COUNCIL ASSESSMENT REPORT

Panel Reference	PPSSNH-86
DA Number	MOD0017/20
LGA	Ku-ring-gai
Proposed Development	Section 4.55(2) modification to a development consent to demolish structures and construct a residential aged care facility, basement parking and landscaping works under the provisions of SEPP (Housing for Seniors or People with a Disability) 2004.
Street Address	144, & 146 Killeaton Street, 1 Yarrabung Road and 1, 3 and 5, College Crescent, St Ives
Applicant/Owner	Estia Investments Pty Ltd C/O Peter Hamilton
Date of DA lodgement	14 February 2020
Number of Submissions	Nil
Recommendation	Approval
Regional Development Criteria (Schedule 7 of the SEPP (State and Regional Development) 2011)	General development over \$20 million and variation to a development standard (building height) of more than 10%. The subject 4.55(2) modification application relates to a development proposal for which the SNPP was the consent authority.

Figure 1.4 Modified South Elevation

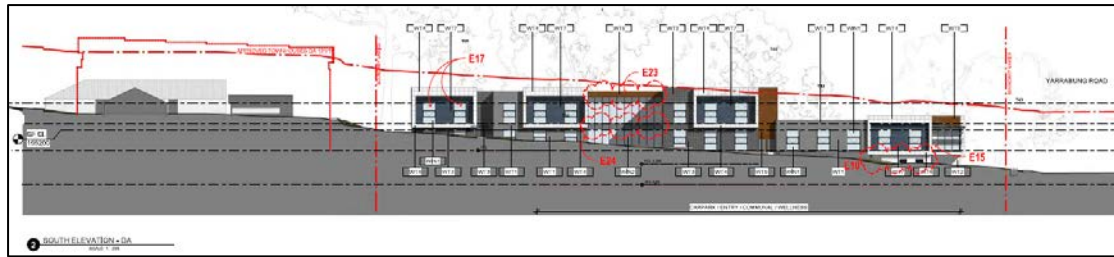
In regard to Clause 34 'Visual and acoustic privacy' the modified proposal addresses these requirements, through the provision of additional privacy screening, maintaining existing landscaping and trees to street boundaries where possible and sensitive window locations into the plans.

In regard to Clause 40 Development Standards, the maximum building height of the modifications at the roof level remain at 8.9 metres which is consistent with the maximum height approved under the original DA0341/16 with the merits of the development standard variation previously dealt with and accepted under Clause 4.6 'Exceptions to development standards' of the LEP. The introduction of new windows to the top floor of the eastern elevation for the new sunroom is more visually dominant than the approved scheme. However, the reduced setback from the eastern boundary of the site will not result in an overall three storey presentation as the eastern elevation of the new sunroom represents a small section of the eastern presentation to the street. The western elevation remains the same, with the exception of window treatments, consistent with the changes to the other elevations.
